Access Compliance Report

Public Rights-of-Way

Intersection ID: 3125	Main Street: JOHNSTON_OEHLER_RD	Cross Street: MOURNING_DOVE_LN	Location: NE
ADA ID: 56CC3640D913	Ramp Type: PerpDiag	Initial Pass/Fail: Fail	Overall Compliance: No
Codes/Mitigation Info/Possible Solution		Field Measurements/Component Compliance

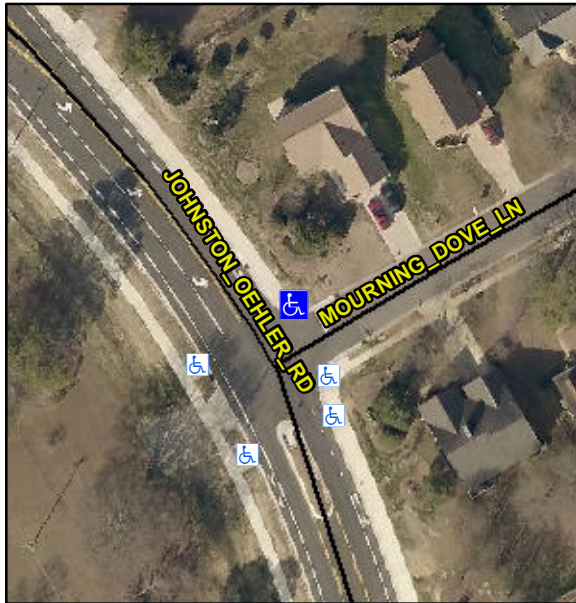
R304.2.2, R304.5.3

Compliance	Description	Data	Compliance	Description	Data
N/A	Ramp Length (in)	90.0	No	Ramp Slope (%)	13.1
Yes	Ramp Width (in)	48.0	No	Ramp XSlope (%)	2.2
N/A	Flare Type LT	N/A	N/A	Flare Type RT	N/A
N/A	Flare Slope LT (%)	N/A	N/A	Flare Slope RT (%)	N/A
N/A	Flare Traversable LT?	N/A	N/A	Flare Traversable RT?	N/A
N/A	Landing Length (in)	N/A	N/A	DWS Provided?	N/A
N/A	Landing Width (in)	N/A	N/A	DWS Contrast?	N/A
N/A	Landing Slope (%)	N/A	N/A	DWS Length (in)	N/A
N/A	Landing X Slope (%)	N/A	N/A	DWS Full Width?	N/A
N/A	Landing Curb? (Y/N)	N/A	N/A	DWS Offset (in)	N/A
N/A	Shared Landing?	N/A			
N/A	Gutter Ponding?	N/A	N/A	Gutter Slope (%)	N/A
N/A	Gutter Lip Ht (in)	N/A	N/A	Gutter X Slope (%)	N/A
N/A	Painted X Walk1?	No	N/A	Painted X Walk2?	No
	X Walk 1 Direction	To W		X Walk 2 Direction	To S
N/A	X Walk 1 Width (in)	N/A	N/A	X Walk 2 Width (in)	N/A
	X Walk 1 Slope (%)	0.1		X Walk 2 Slope (%)	2.4
	X Walk 1 X Slope (%)	2.6		X Walk 2 X Slope (%)	0.4

Remove & Replace Curb Ramp With Two New Directional Ramps or Equivalent.
